Plan Commission

Agenda

Monday, June 26, 2017

SUBJECT: Recommendation regarding a Site Plan for a building addition for Green Bay Packaging INC at 2275 American Boulevard in De Pere (Parcel WD-L492-B-2). Submitted by GRAEF.

SHEET NO.  
1 of 5

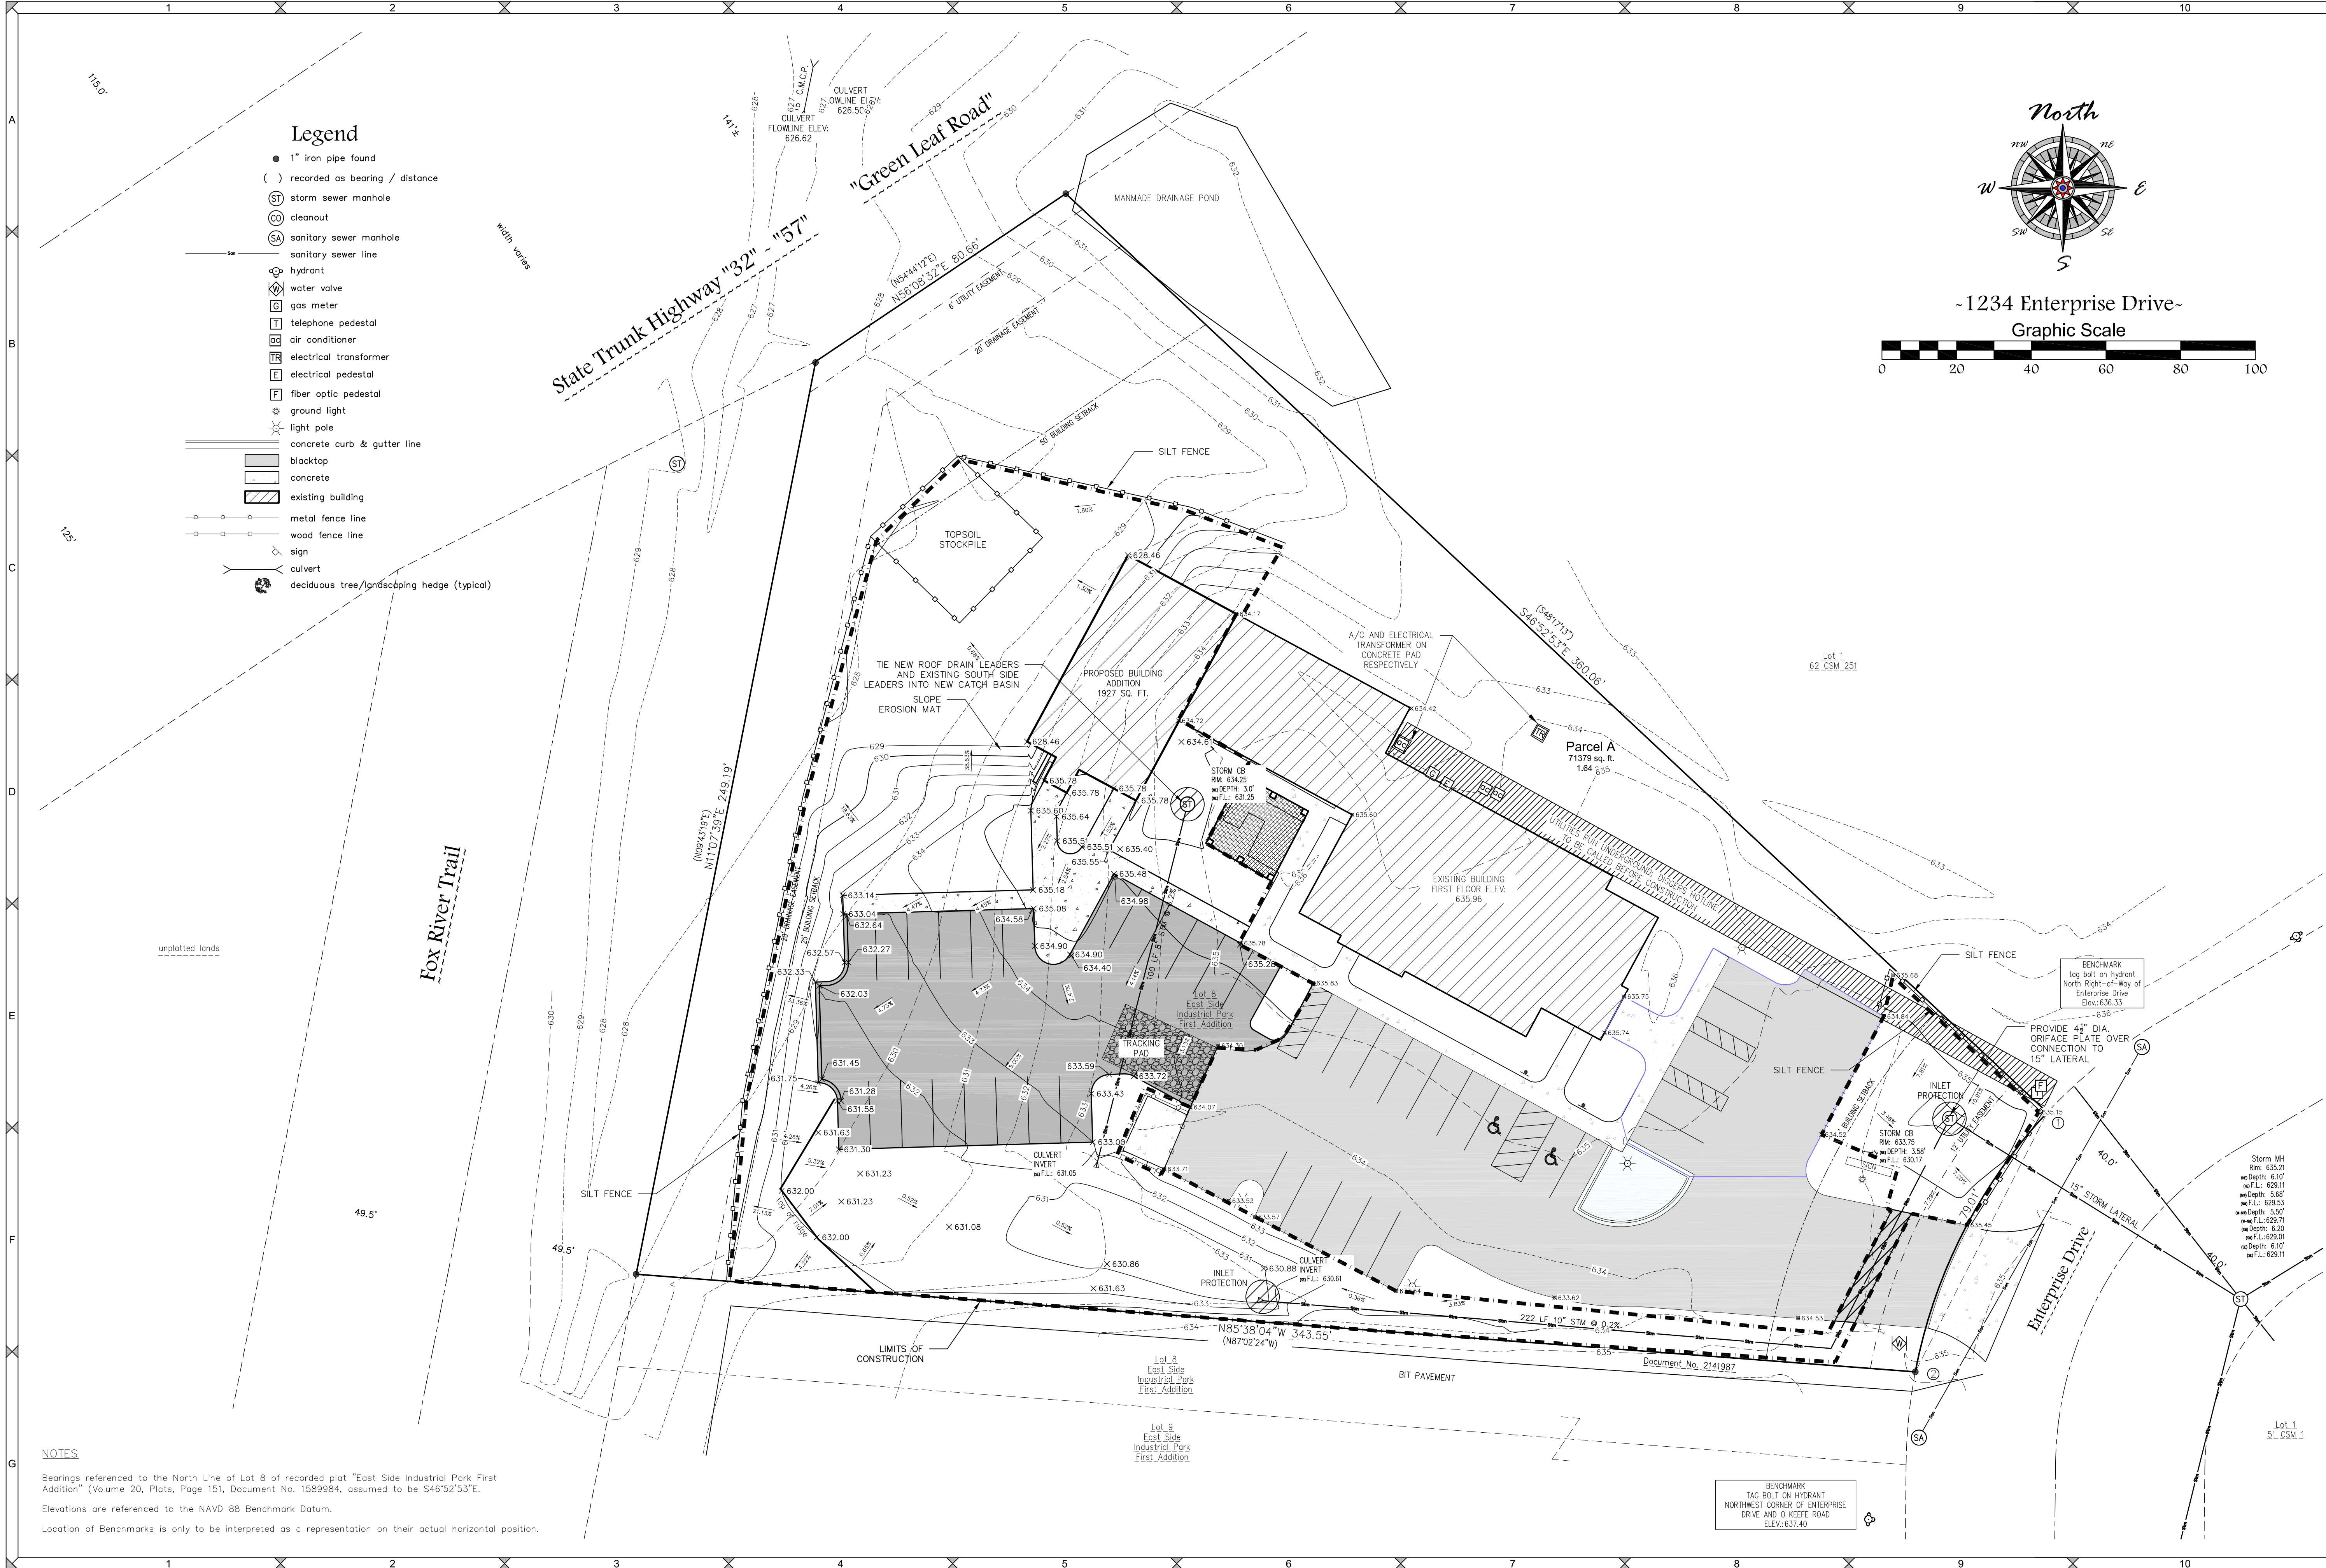
1. Provide a map of the critical route for flow off the site during construction to correspond with the WDNR Soil Loss & Sediment Discharge Calculation Tool. (SWMP)
2. Show City water main and water service to the property on all sheets.
3. Sheet 2 of 5: need to list striping as 4" Striping (TYP).

1. Identify the Code required number of parking stalls on Sheet 2 of 5 on the site plan. Offices require 4 spaces per 1,000 gross square feet of floor area (at least 24 for the site plan and 20 new stalls are proposed for a total of 39 stalls onsite).
